Application No. 10/581,328
Reply To Office Action dated June 5, 2009
Response dated September 3, 2009

AMENDMENTS TO THE DRAWINGS

REMARKS

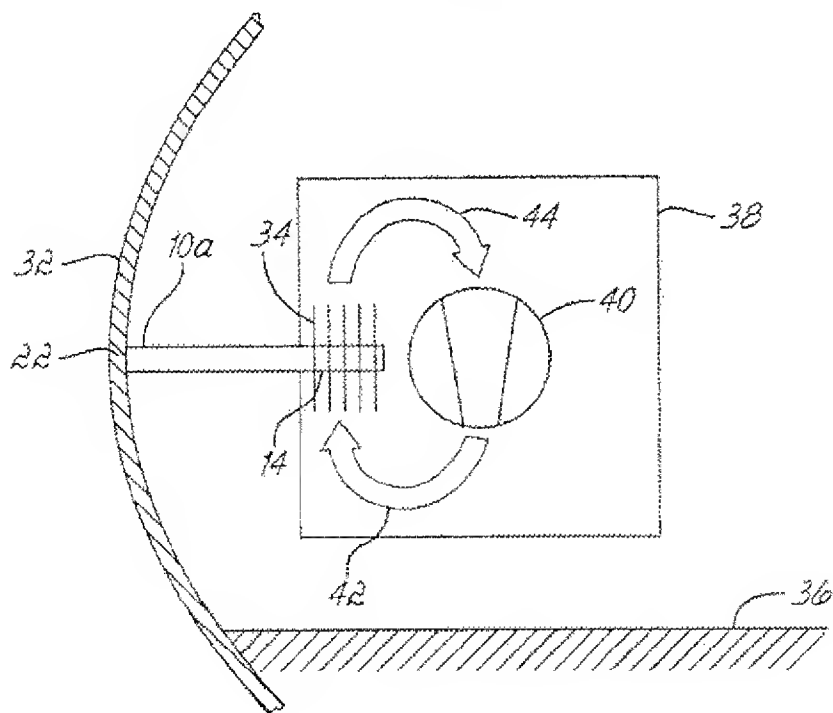
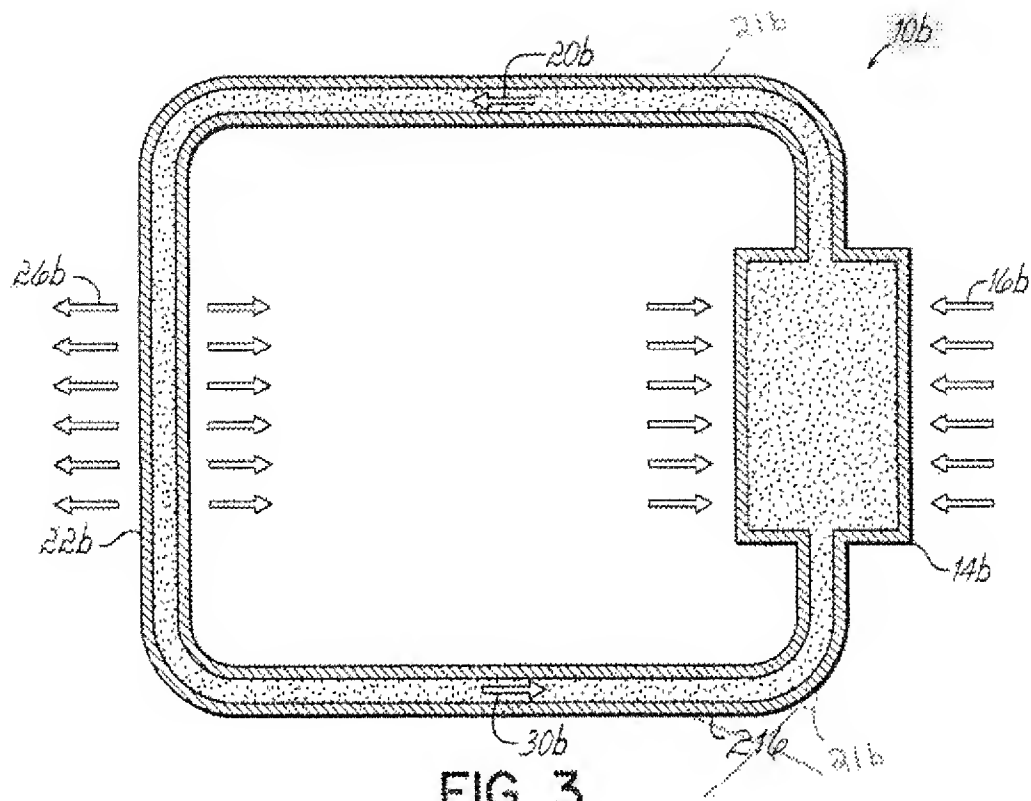
Attached are three drawing sheets showing the changes made to Figures 3, 5, 6, and 7,
and three replacement sheets for review and approval by the Examiner.

The drawings were objected to for failing to show every feature of the invention specified in the claims as well as for failing to show reference numeral 156 from the detailed description. Applicants have amended Figures 3, 5, 6, and 7 to correct typographical errors and to overcome these objections. More specifically, Figures 6 and 7 have been amended to show the regulation device (252, 352), the temperature sensor (250, 352) and the associated control lines (254, 256, 354, 356), thereby showing the embodiments of claims 27-31. A corresponding explanatory sentence for these features has also been added to paragraph [0051] of the specification: "Again the regulation device 252 is operatively coupled to the ventilator 240 via control line 254, to the temperature sensor 250, and to the regulator valves 278, 280, 286 via control lines 256." These amendments are fully supported by the original specification at paragraphs [0016], [0047], and [0056]. Applicants

FIG. 5

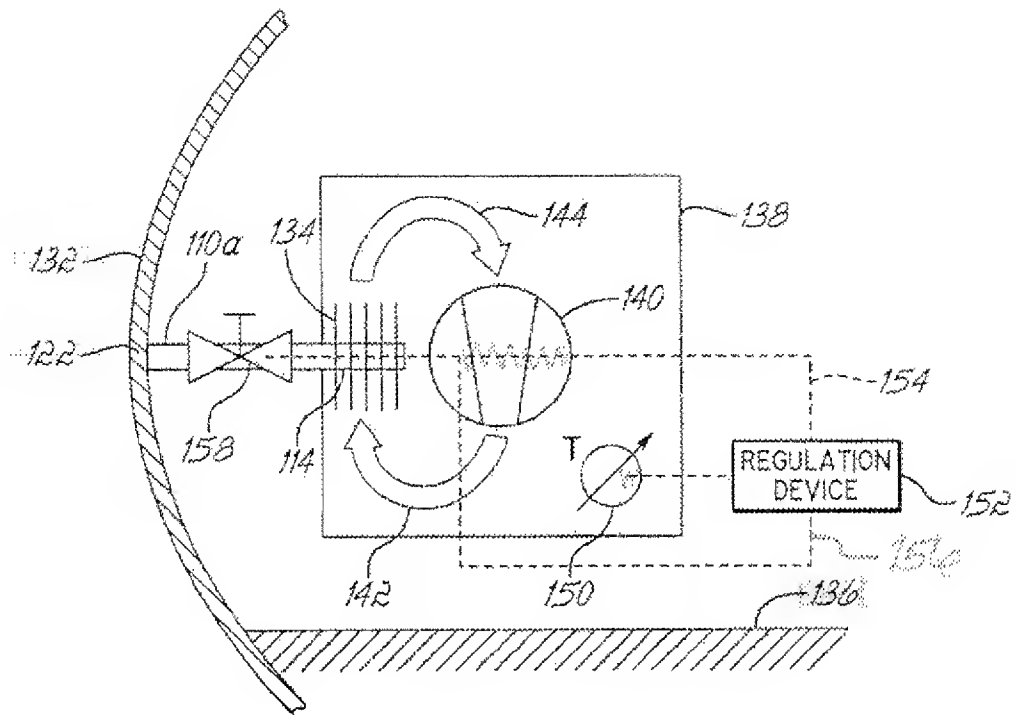
also observe that paragraph [0051] explains that the quantity of heat transferred by the system of Figure 6 can be changed by controlling the ventilator and/or the regulator valve, which is precisely the same control operations described for Figure 5. Thus, it is proper to amend Figures 6 and 7 to include the regulation device, the temperature sensor, and the control lines of Figure 5. Applicants respectfully request that the objections to the drawings now be withdrawn.
